**From:** Christina Kirsch [REDACTED]  
**Sent:** Thursday, 21 September 2023 7:10 PM  
**To:** Planning Panels - Northern Beaches; ceekirsch@gmail.com  
**Subject:** Northern Beaches Local Planning Panel Notice DA 2021/1612  
**Attachments:** letter.pdf

## B9 Rear Boundary Setbacks

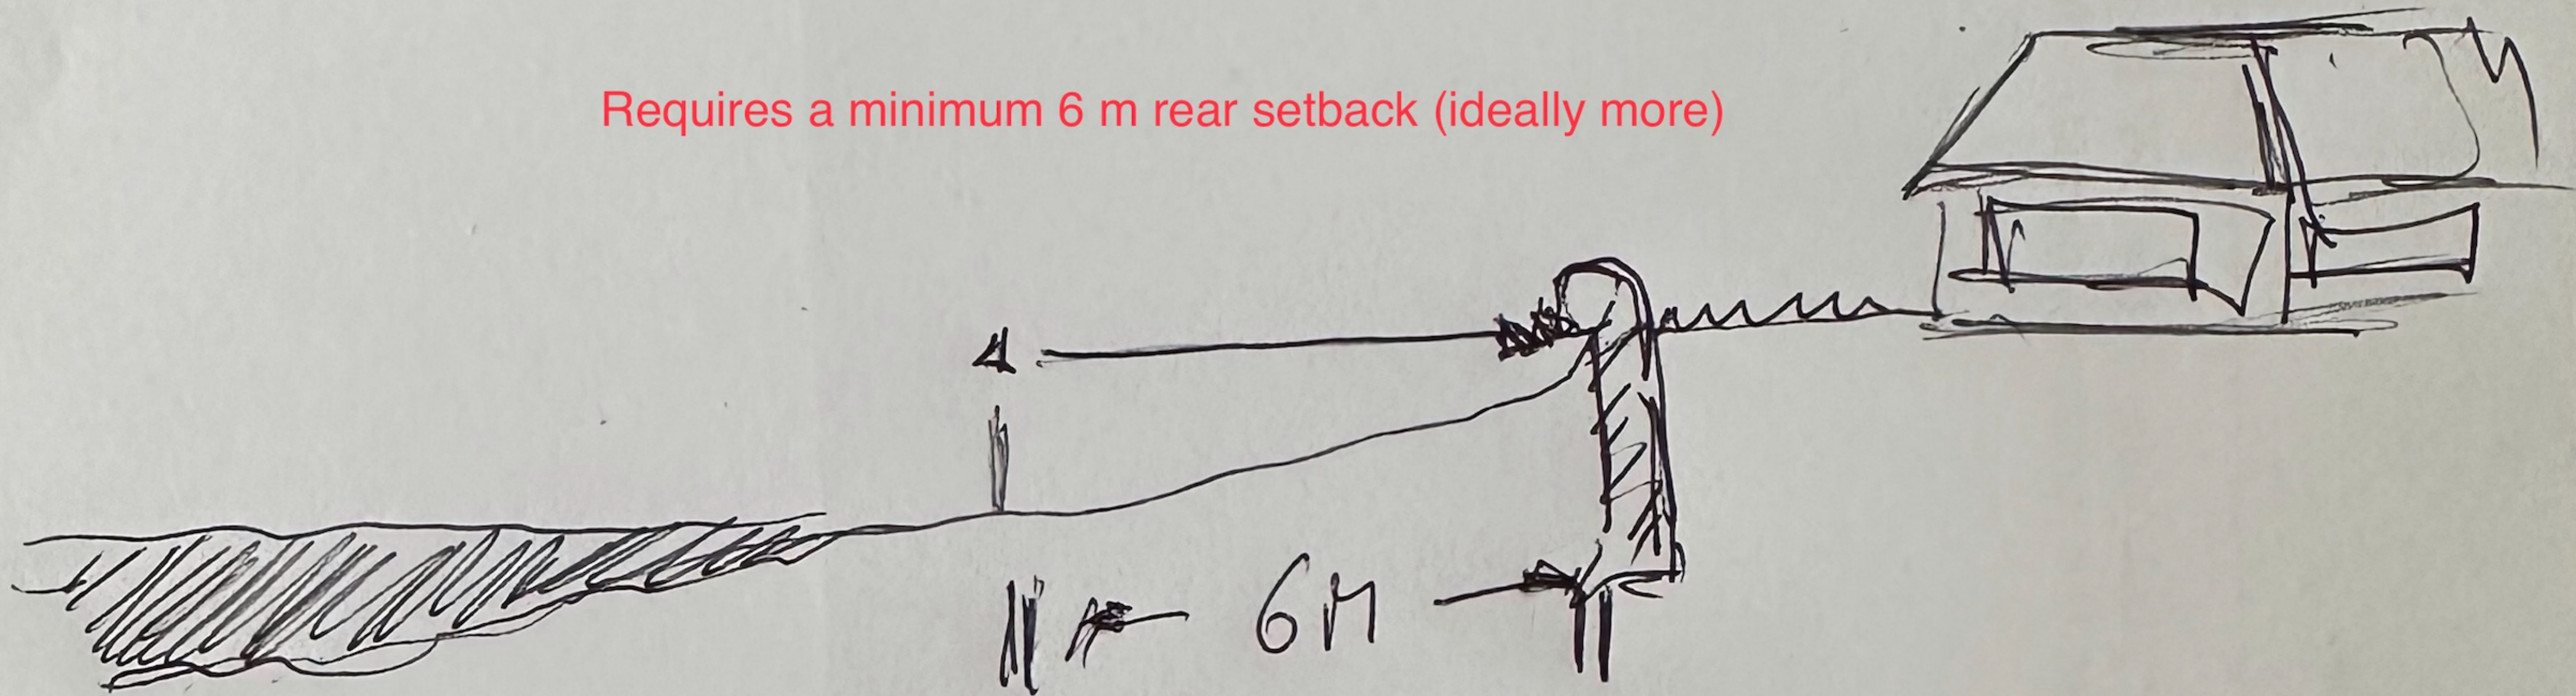
Inappropriate - landscape not really in the visual field of the impacted public / beach user

The 'deep soil landscape' and 'landscaping' is on private property and 2 meters above anyone walking along the beach. Therefore the landscaping does NOT add to the visual amenity of the beach, does not make up for the loss in beach amenity and the negative visual impact. No beach visitor would ever prefer to look at a concrete wall, even if there are some shrubs and 'landscaping' on top of it.

Therefore the rear-setback needs to be preserved to minimise the negative impact on the aesthetics and available beach area. The owner of the beach is the Crown, or rather their Australian public and there needs to be a compromise that acknowledges the negative impact on the public asset (the beach). The preference of any beach goer would be to have NO protective work (or managed retreat); therefore the protective work needs to be as far set back as possible, but at the very least the required 6 meters

Rear Setback

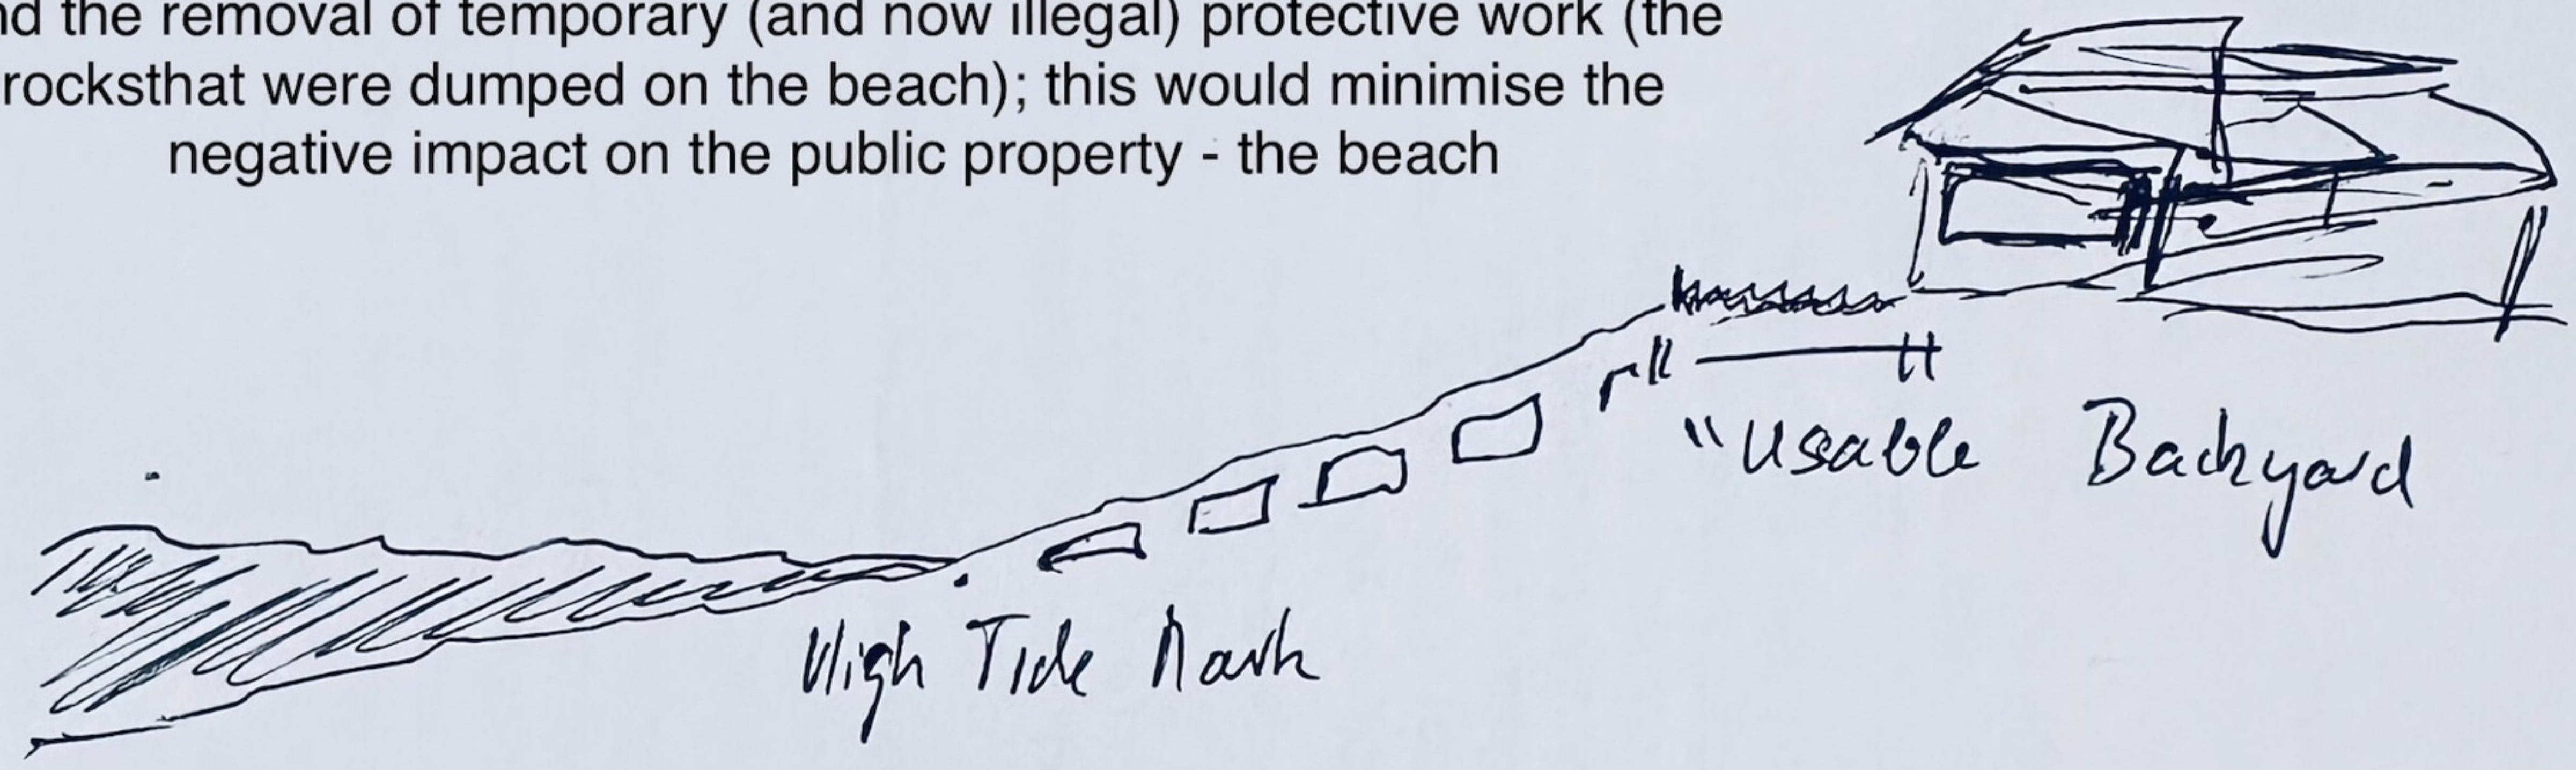
Requires a minimum 6 m rear setback (ideally more)

The preferred option would be a revetment on the private property, and the removal of temporary (and now illegal) protective work (the rocks that were dumped on the beach); this would minimise the negative impact on the public property - the beach

The proposed design - with non-compliant rear-setback is an unacceptable grab for increased property (assuming 12 m width and on average a 3 m height at the Seawall, the increase in cubic meters would be 108 cubic meters of added property); the backfill would result in an increase in size of the usable 'rear backyard', rob beach goers of a visually attractive beach; create overshadowing on the public beach; the maximum height of any fence would be 1.8 meters and no property owner would be allowed to build a 2-7 m wall directly adjacent to a neighbour - this should not be allowed on a publicly owned beach
